9 – 21 BEACONSFIELD PARADE

LINDFIELD, NSW

**STATE SIGNIFICANT DEVELOPMENT
PROPOSAL**

**ARBORICULTURAL IMPACT
ASSESSMENT REPORT**

Figure 2, showing T62 encroachment area

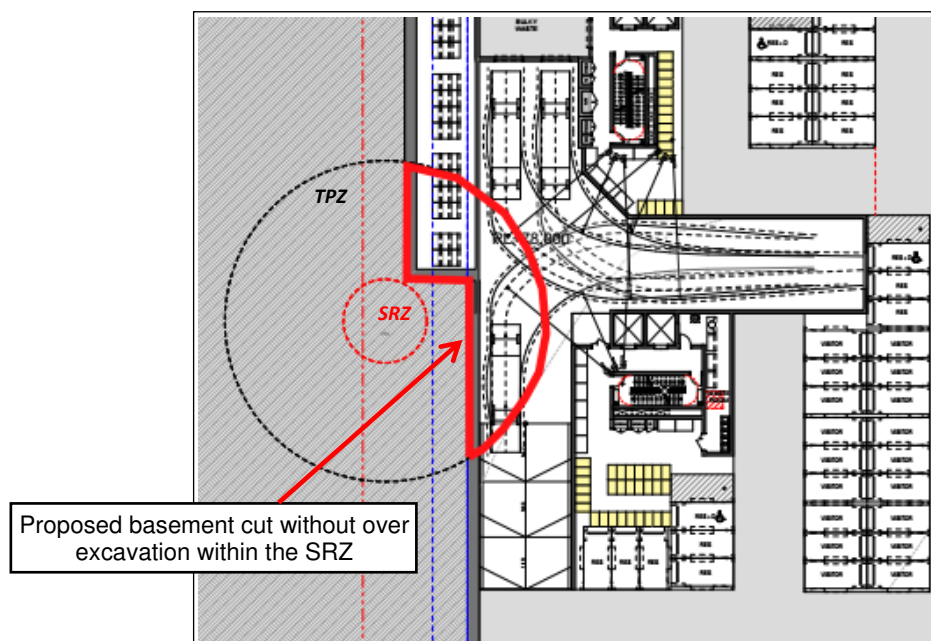
Based on the basement footprint a *High-level (28%)* TPZ occupancy occurs by the design footprint with design located just outside the SRZ. Given the proximity of the basement cut and likely requirement for over excavation extending within the SRZ, in addressing other *TPZ considerations* noted within AS4970 / 3.3.4; tree age and establishment within the site indicates the tree may not tolerate construction disturbances, or the proposed occupancy within the TPZ.

The trees' location to the proposed basement and design footprint makes it very difficult to ensure the tree will remain viable as indicated within AS4970 *Protection of Trees on Development Sites – 2009* section 3.3.3 *Major encroachment*. Mitigating impacts could consist of:

- a) No over excavation beyond the basement footprint as shown within construction drawings.
- b) All excavations within the TPZ are to be supervised & certified by an appointed site arborist clean cutting all encountered tree roots in accordance with AS4970 – 2009 Section 4.5.4 *Root protection during works within the TPZ*, such that tree roots are not damaged or ripped beyond the point of excavation by site machinery.

- c) Retaining existing soil levels (RL's) within a tree protection area (TPA) extending the remaining tree protection zone outside the design footprint is to be adopted within construction drawings.

- d) Given tree protection fencing would be restrictive for construction access within the site, ground or root protection mats are recommended to cover the TPZ as indicated within Appendix- B item [C] *ground protection*.

- e) At no stage should excavation occur within the SRZ.

Figure 3, showing T90 & 91 protection area

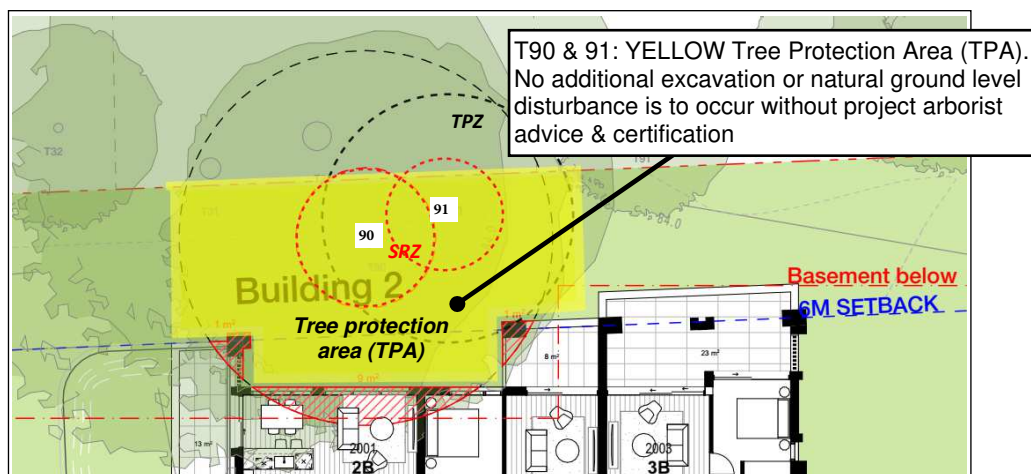
Tree 90; displaying a significant lean and canopy mass over the neighbouring property receives a *Minor* (6.9%) TPZ encroachment without SRZ occupancy. In addressing other *TPZ encroachment considerations* noted within AS4970 / 3.3.4; demolition and construction occupancy is located within the tension root zone (roots taking up strain of tree lean), indicating works within the TPZ may disrupt the tension root zone (TPZ).

Similar applies to tree 91 where the entire tree extends within the neighbouring site.

To ensure the trees remain viable the following tree management and assessment of any additional information is required:

- a) Demolition of the existing tennis court and features within TPZ's are to be conducted under the supervision and certification of an appointed site arborist.

- b) Demolition must be conducted in a tree sensitive manner to ensure critical underlying tree roots are not damaged or disturbed by works.
- c) Prior to demolition the SRZ radiuses are to be certified as fenced off with tree protection fencing. At completion of demolition the remaining TPZ's are to be certified as protected with ground protection boards covering the TPZ or as indicated and certified by an appointed project arborist, see Appendix- B Item [C] *ground protection*.

- d) To avoid additional encroachment impacts within the TPZ there is to be no over excavation beyond the basement footprint as shown within construction drawings.

- e) No additional excavation for services are to occur within the remaining TPZ deep soil areas with the 6m setback within TPZ's managed as a Tree Protection Area (TPA), see Section 2.3 *h*).

- f) The natural and existing ground levels within tree protection zones or specified tree protection areas are to remain without excavation cut or site grading.

- g) During main construction activities an appointed project arborist is recommended to inspect all tree protection at four (4) week intervals ensuring fenced SRZ radiuses remain in place and all ground protection is consistent with protecting critical roots taking up strain of tree lean within the TPZ.

- h) Should additional works be required within the designated Tree Protection Area (TPA) as indicated within Figure 3, prior project arborist advice & certification is required.
